**CITY OF BLOOMINGTON  
PLAN COMMISSION AGENDA  
May 5, 2014 @ 5:30 p.m.**

**BLOOMINGTON PLAN COMMISSION  
STAFF REPORT  
Location: 306 E. Kirkwood Ave.**

**CASE #: SP/UV-34-13  
DATE: May 5, 2014**

**Subject:** SP/UV-34-13 & UV-46-13, Pavilion Center Site C  
306 E. Kirkwood Ave.  
Site Plan & Use Variance

SHEET NUMBER <b>A5</b>	
SHEET DESCRIPTION <b>NORTH ELEVATION</b>	
PROJECT NO. 13018.02	DATE 3/24/2014
GMS-PAVILION PROPERTIES, LLC. PAVILION CENTER ON KIRKWOOD BLOOMINGTON, INDIANA

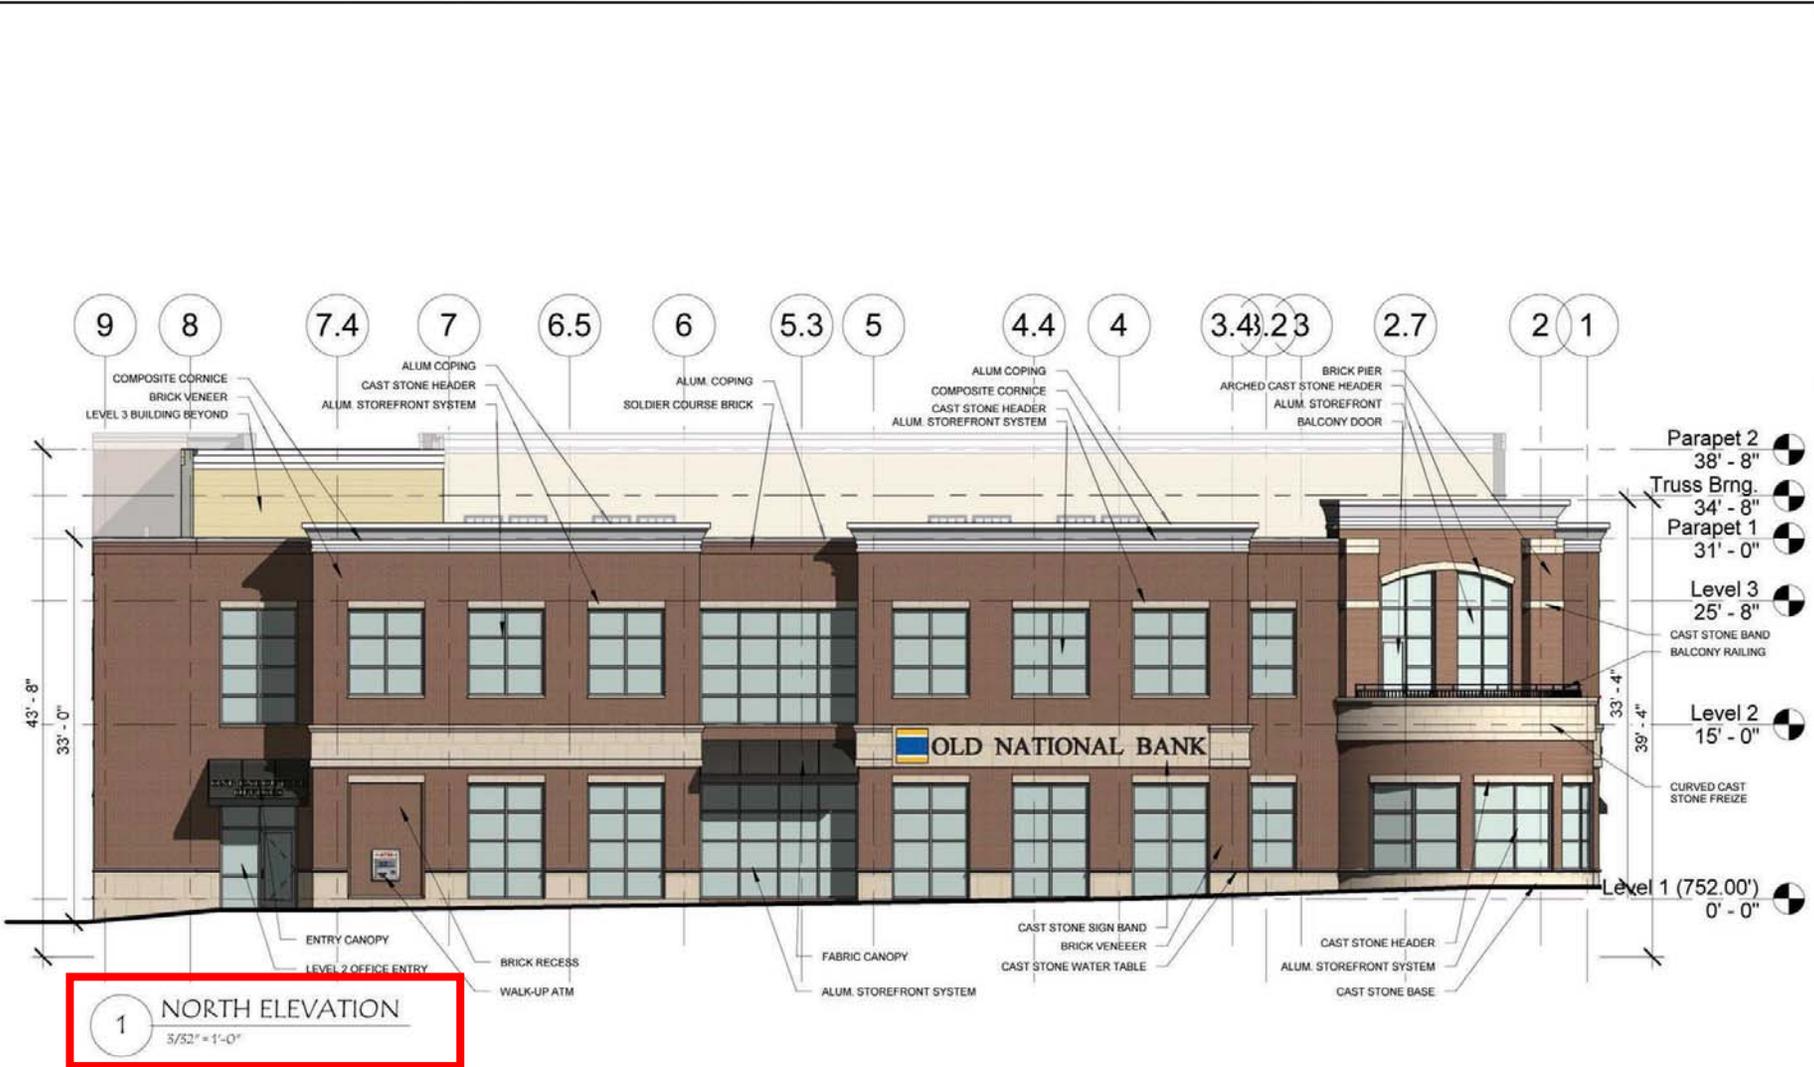
**Void-to-Solid Ratio:** The ordinance requires a 60% ratio on the first floor and 20% for upper floors. The proposal complies with the upper floor standard, but does not comply with the ground floor standard. Fifty percent (50%) is proposed along Kirkwood and 49% is proposed along Lincoln Street. This requires waiver approval from the Plan Commission. The original building proposal complied with the 60% requirement, but there has been no reduction in the actual amount of building voids on either street. The reason the percentage has dropped is that the first floor height has been raised to create a tall 2-story building appearance on Kirkwood.

Although staff cannot support the overall site plan proposal, staff would support a design waiver for this style of building. While not strictly complying with the void-to-solid standard, the proposed building does incorporate ample amounts of void openings along both street frontages.

Although staff does not support the overall site plan proposal, staff would support a design waiver from the height standard of the district. The proposed building has a tall two-story configuration on Kirkwood Avenue and incorporates a large step-back design for the third story. Since the 44 foot height of the building is a function of grade rather than scale, staff could support a waiver from the 40 foot height standard.
